ADDENDUM No. 1

Drawings and Specifications

Dated June 23rd, 2020

Leon Valley Community Center Upgrades

DRAWING NO.: **A1.2** of 5
DRAWN BY: NCT
CHECKED BY: CEF
APPROVED BY: CEF
JOB NO.: 170165.310

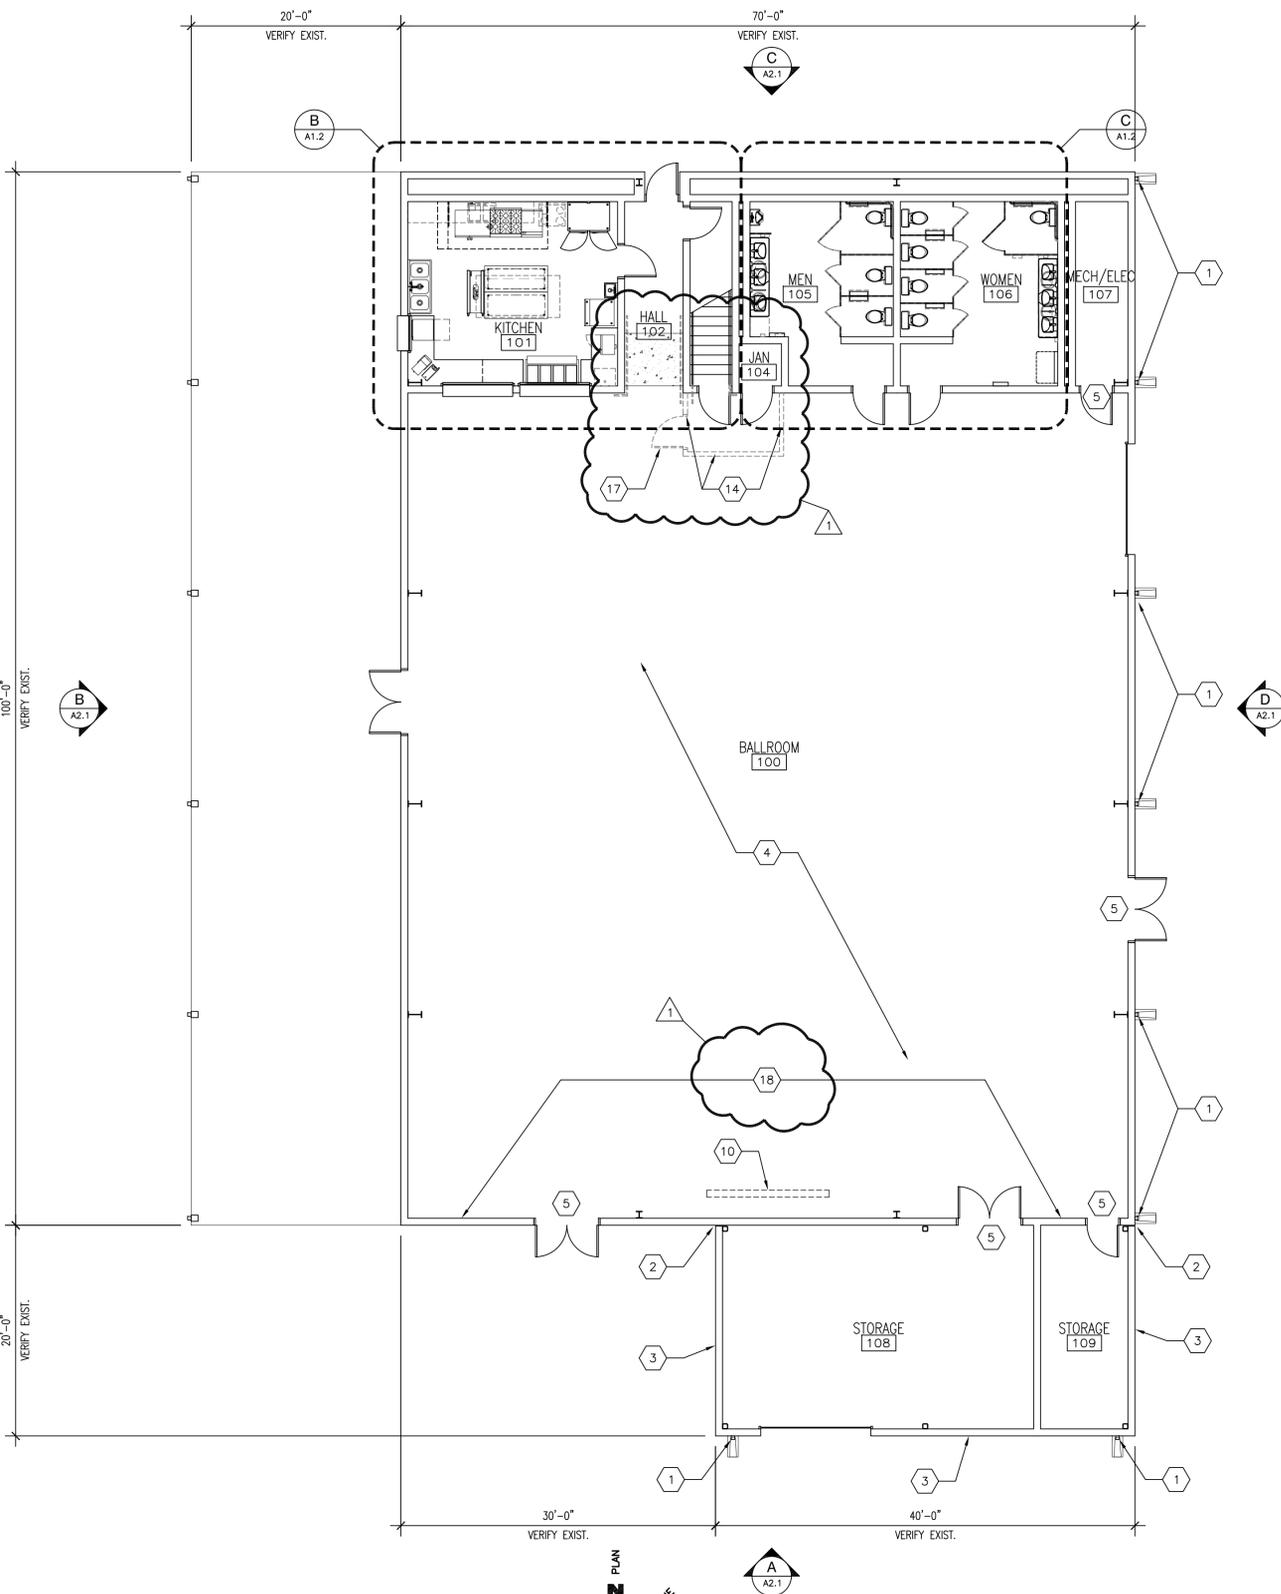
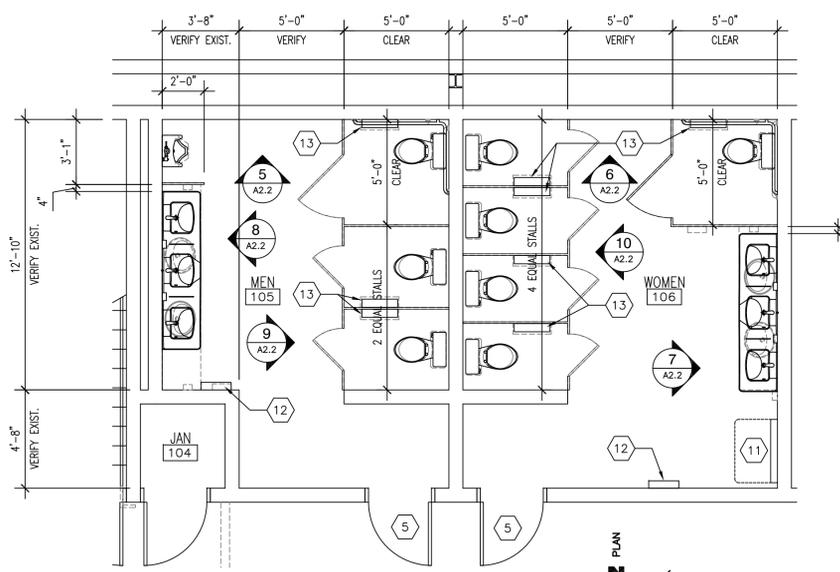
1. Sheet A1.2 – Floor Plan & Enlarged Plans:

- a. REMOVE existing room currently named Foyer 103.
- b. RELOCATE existing door from Foyer 103 to existing stair framed opening.
- c. REMOVE sections of existing hand railing.
- d. ADD wood chair railing to wall, on South end of existing Ballroom.

18	INSTALL NEW STAINED/SEALED 2X8 WOOD CHAIR RAIL, ON SOUTH BALLROOM WALL, TO MATCH EXISTING. NEW RAIL TO BE A TOTAL OF APPROXIMATELY 53'-0" LONG.

DRAWING NO.: P1.0
1 of 5
DRAWN BY: RS
CHECKED BY: JW
APPROVED BY: JW
JOB NO.: 20111

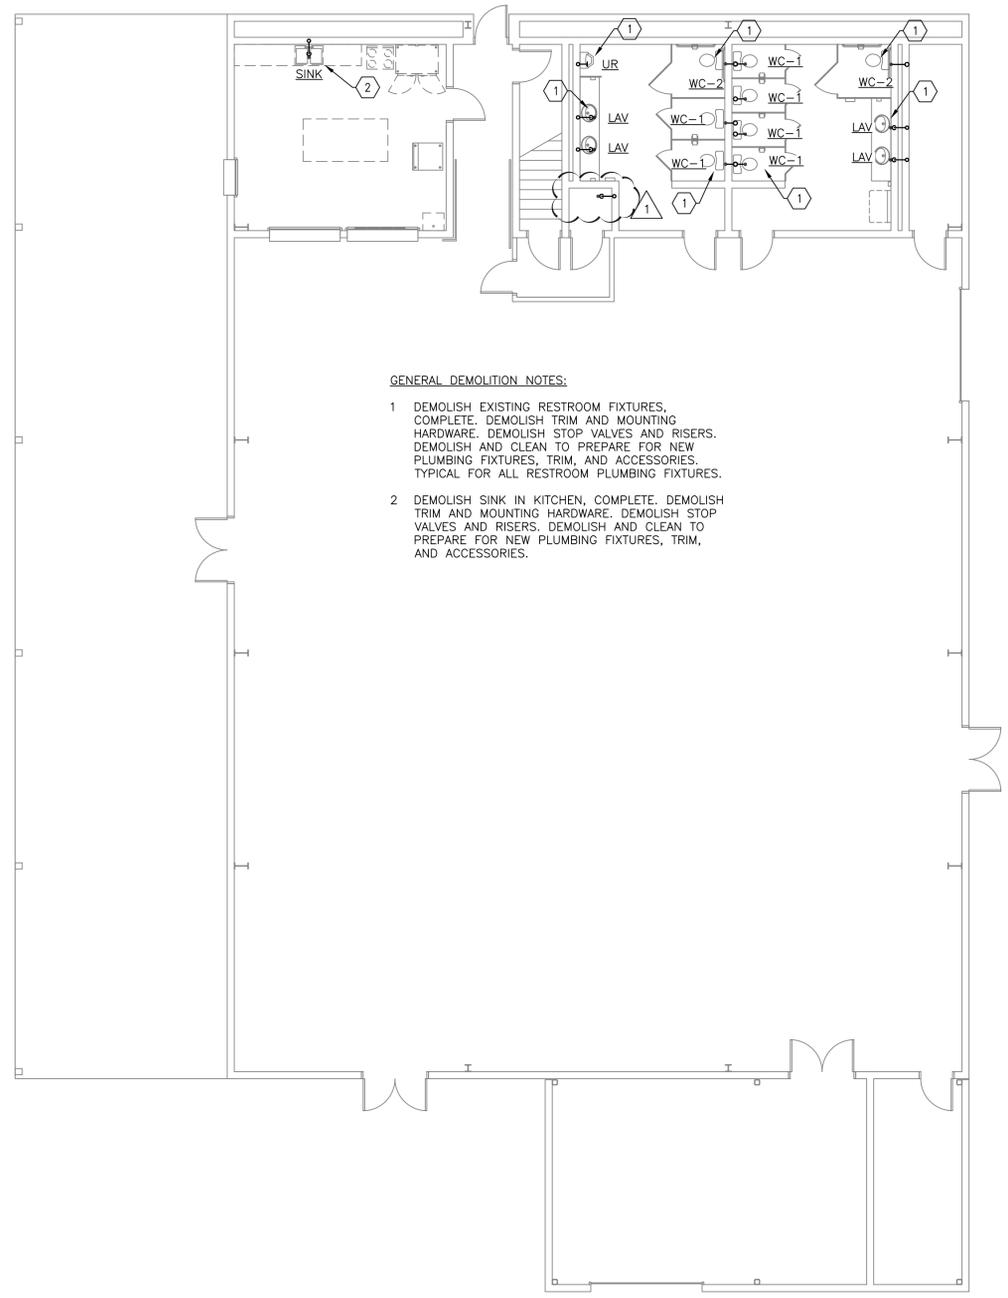
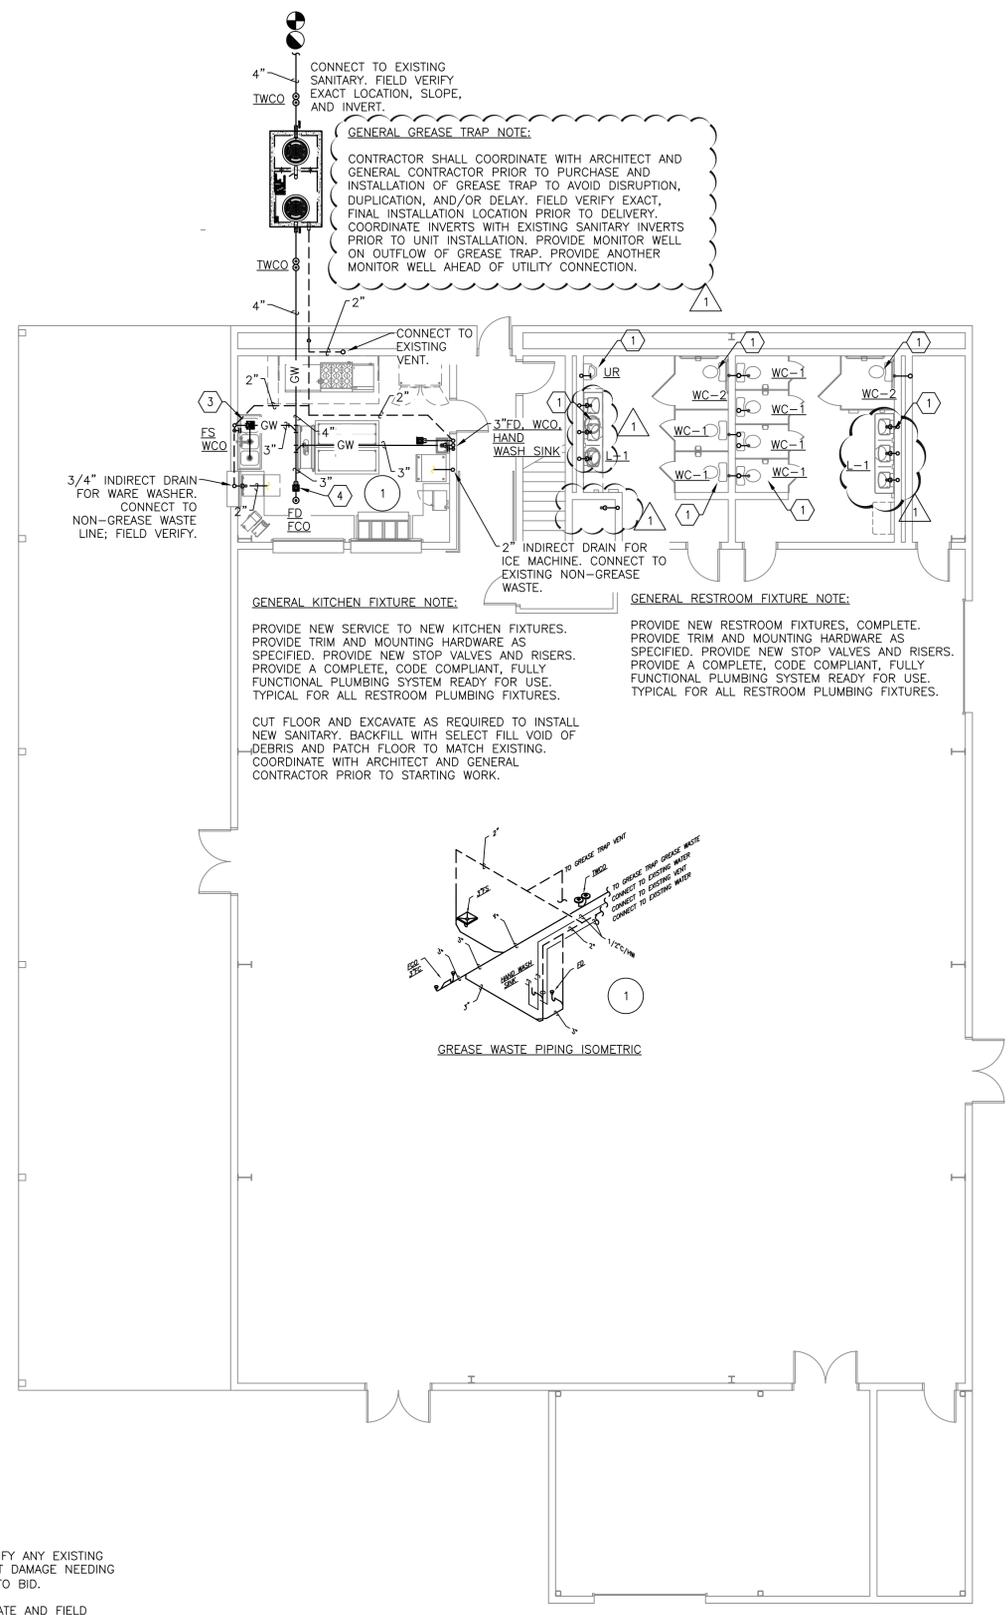
3. Sheets P1.0, P1.1, P2.0 & P2.1:

- a. REVISE Janitor Sink Basin. The sink basin shall be modified to fit the specified mop sink scheduled on Sheet P2.0.
- b. REVISE item marked (L-1) on Plumbing Fixture Schedule, Sheet P2.0.
- c. A detail for cutting the existing slab is included to assist with mop sink modification.
- d. REVISE General Grease Trap Note.

GENERAL GREASE TRAP NOTE:
CONTRACTOR SHALL COORDINATE WITH ARCHITECT AND GENERAL CONTRACTOR PRIOR TO PURCHASE AND INSTALLATION OF GREASE TRAP TO AVOID DISRUPTION, DUPLICATION, AND/OR DELAY. FIELD VERIFY EXACT, FINAL INSTALLATION LOCATION PRIOR TO DELIVERY. COORDINATE INVERTS WITH EXISTING SANITARY INVERTS PRIOR TO UNIT INSTALLATION. PROVIDE MONITOR WELL ON OUTFLOW OF GREASE TRAP. PROVIDE ANOTHER MONITOR WELL AHEAD OF UTILITY CONNECTION.

DRAWING NO.: **M1.1**

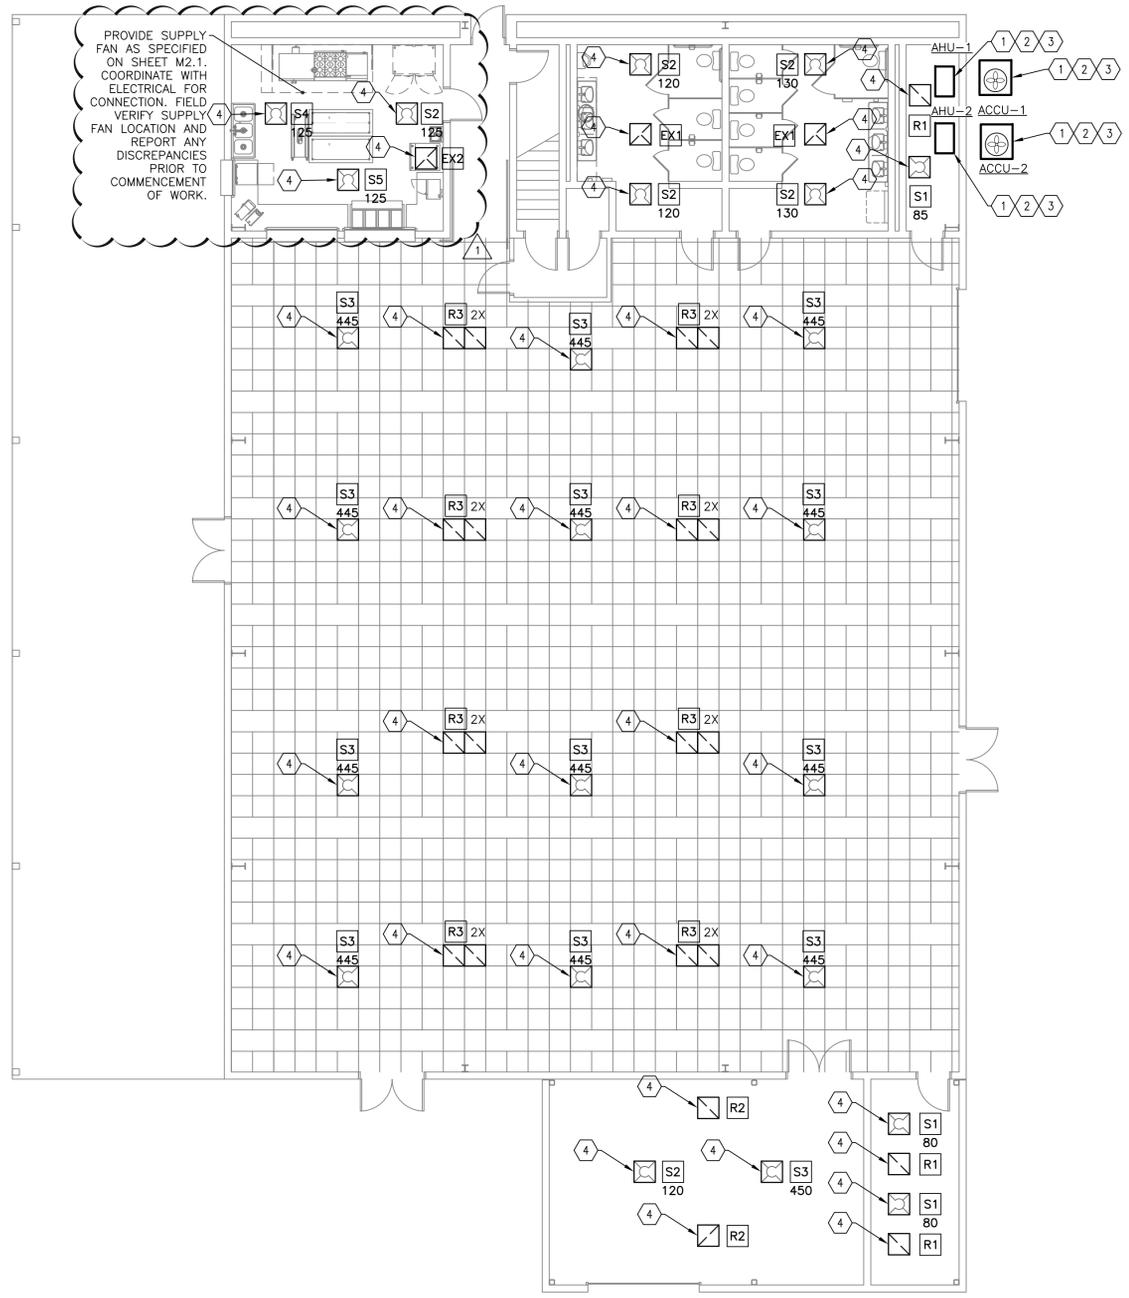
4. Sheets M1.1 & M2.1:

- a. REVISE Kitchen. The specified air devices on M1.1 have been modified and a supply fan has been added to better service the kitchen.
- b. REVISE Air Devices Schedule on M2.1 to accommodate revisions made on Sheet M1.1.
- c. An air balance schedule and supply fan schedule have been added.
